# Town Center Subarea Plan Public Comments and Responses

**Public Open House –December 4, 2018**

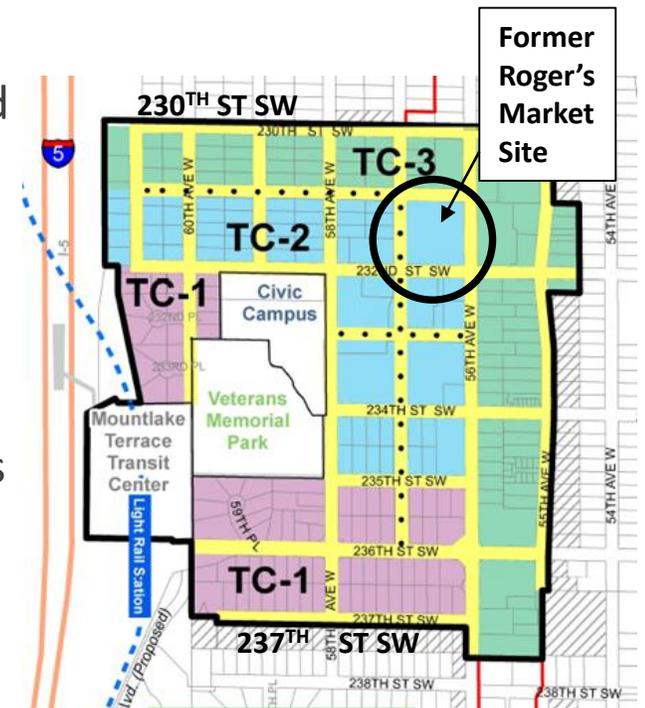
14. Several questions related to parking fees, structures and ratios.

**Staff Response:** A parking management plan is typically required for larger mixed-use projects. The updated zoning text will address shared parking between different uses and peak/off-peak hours. On-street parking is usually free albeit some jurisdictions regulate hours of use. Parking structure design is based on the type of use, number of stalls, access to local streets, servicing and loading requirements. The designs are reviewed by the City during plan review to ensure consistency with parking regulations including established parking ratios. Parking ratios for different use types and demographics will be considered as part of the updated development standards.
